RE: Washington State Energy Code Adoption

RE: Washington State Energy Code Adoption, technical correction, air leakage rates.

Figure 5. Average Modeled EUI of a Single-Family Dwelling (by EUI) in 2018 – Gas vs Electric

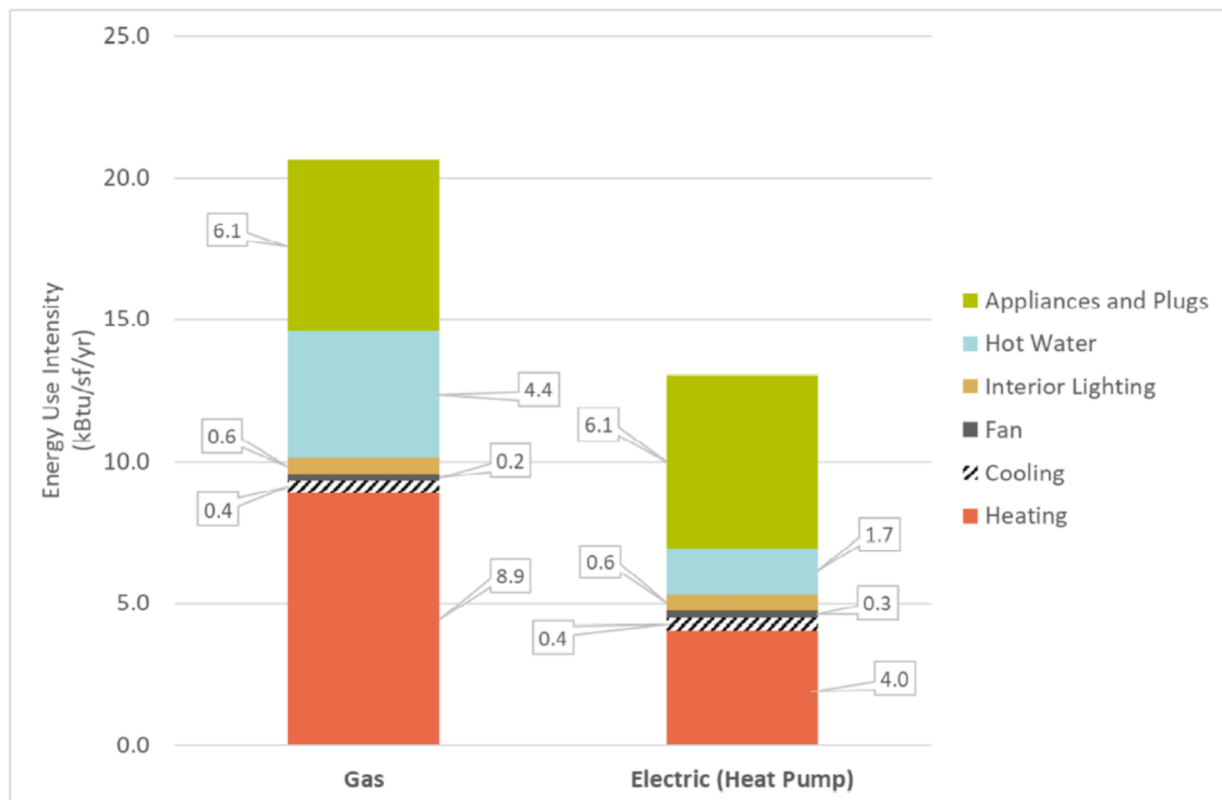
The adoption of Heat Pumps as a base prescriptive requirement is the best technical solution to meeting the policy objectives for energy savings and carbon emissions. This was made evident in the 2018 energy code analysis commissioned by SBCC.¹ I have copied figure 5 from this report below.

Figure 5 of illustrates that the heat pump home uses about half the space and water heating energy as the gas home. This report also shows the gas-heated home has reduced energy use by 44%, compared to the 2006 state energy code. The heat pump home achieves a 64% reduction compared to the 2006 baseline. Wide adoption of heat pumps will effectively move the code toward the energy reduction objectives required by statute.
